**SUBDIVISION,
PLANNED UNIT DEVELOPMENT, &
SIDEWALK WAIVER STAFF REPORT**

Date: May 15, 2014

<u>NAME</u>	Tucker Place Subdivision
<u>SUBDIVISION NAME</u>	Tucker Place Subdivision
<u>LOCATION</u>	117 Batre Lane (Northwest corner of Batre Lane and Gaillard Street)
<u>CITY COUNCIL DISTRICT</u>	District 7
<u>CURRENT ZONING</u>	R-1, Single-Family Residential
<u>AREA OF PROPERTY</u>	8 Lots / 3.1± Acres
<u>CONTEMPLATED USE</u>	Subdivision Approval to create eight legal lots of record from an existing metes-and bounds parcel, Planned Unit Development approval to allow reduced front and side yard setbacks in a proposed Subdivision, and Sidewalk Waiver to waive construction of a sidewalk along Batre Lane and Gaillard Street.
<u>TIME SCHEDULE FOR DEVELOPMENT</u>	Immediate.

DETAIL SITE PLAN

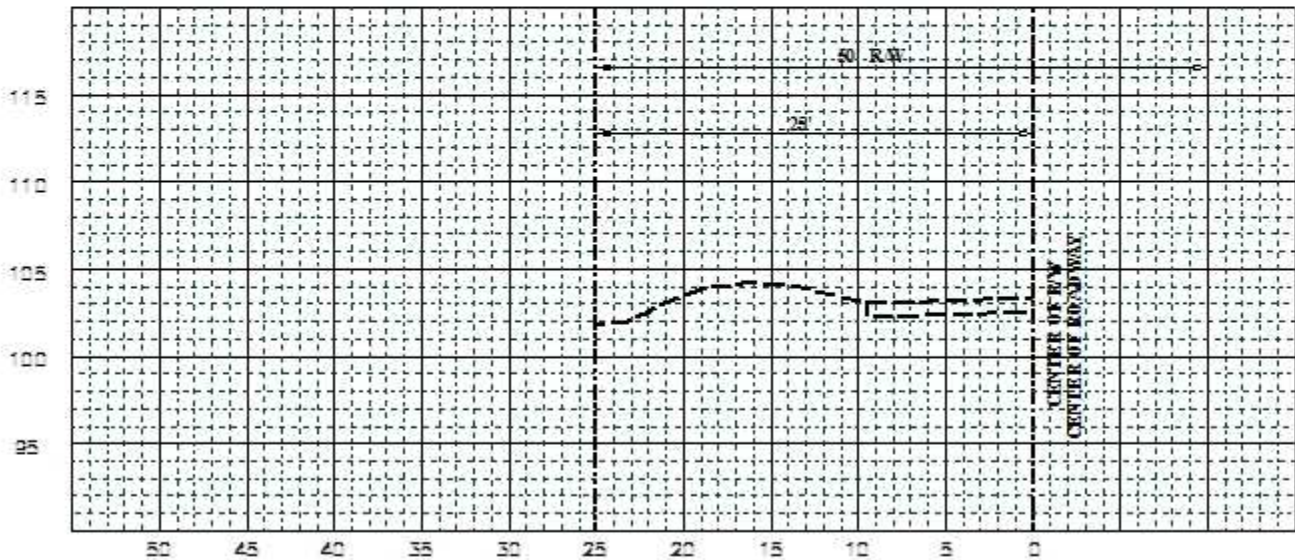
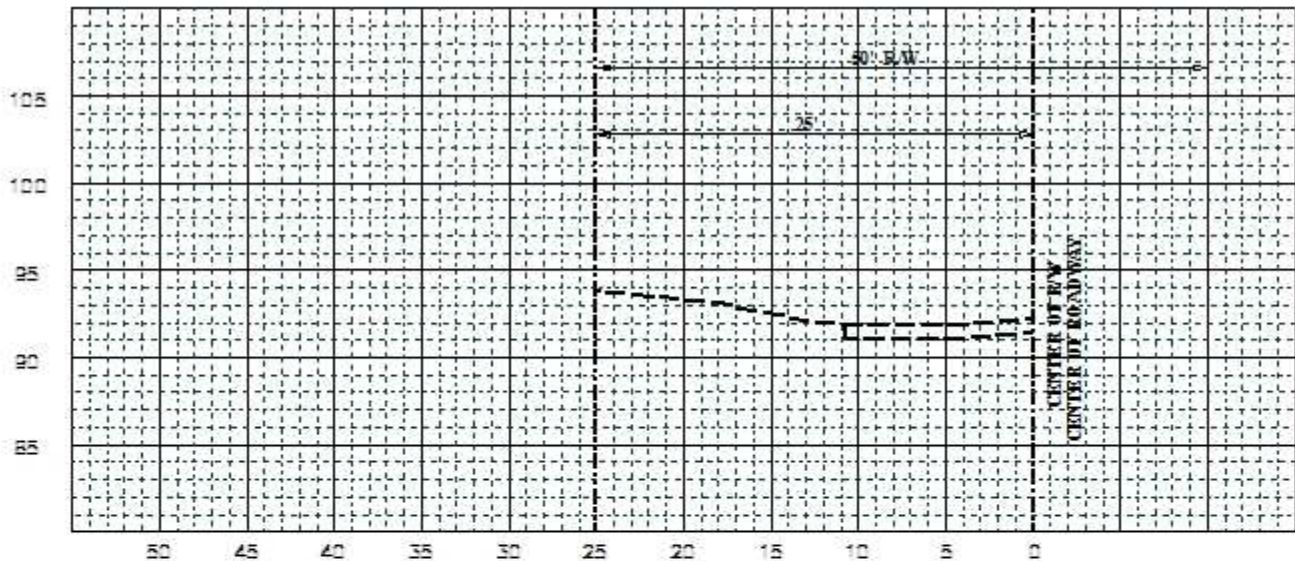
Batre Lane: It appears that there is sufficient room within the ROW, or within the property, for the construction of a sidewalk that could be permitted through the ROW Permit process.

Galliard Street: It appears that there is sufficient room within the ROW, or within the property, for the construction of a sidewalk that could be permitted through the ROW Permit process.

Installation of a sidewalk will have a negative impact on the existing tree roots along Gaillard Street and Batre Lane.

With regard to the Sidewalk Waiver request, the applicant states that there are extreme slopes on the site and that a sidewalk Waiver would be appropriate based on the constructability of a sidewalk in this area. It is further pointed out that there are no sidewalks in the vicinity. It is also stated that the narrow right-of-way conditions in this area do not allow for sidewalks to be built and that a sidewalk in this area would provide limited, if any foot traffic because it would be a sidewalk to nowhere.

A review of the site plan by City Engineering has determined that along both streets it appears that there is sufficient room within the right-of-way, or within the property, for the construction of a sidewalk. However, Urban Forestry has determined that the construction of a sidewalk along either street would have a negative impact upon the existing tree roots. In light of the fact that there are no other sidewalks within the immediate area, and in the interest of protecting the existing trees along the street frontages, staff is of the opinion that the Sidewalk Waiver should be approved, but only upon condition that the existing trees within the sidewalk area remain; if the trees are cleared, the sidewalks must be constructed..

Sidewalk Waiver: Based upon the preceding, the Sidewalk Wavier is recommended for approval, subject to the trees within the sidewalk area remaining: if the trees are removed, the sidewalks must be built.
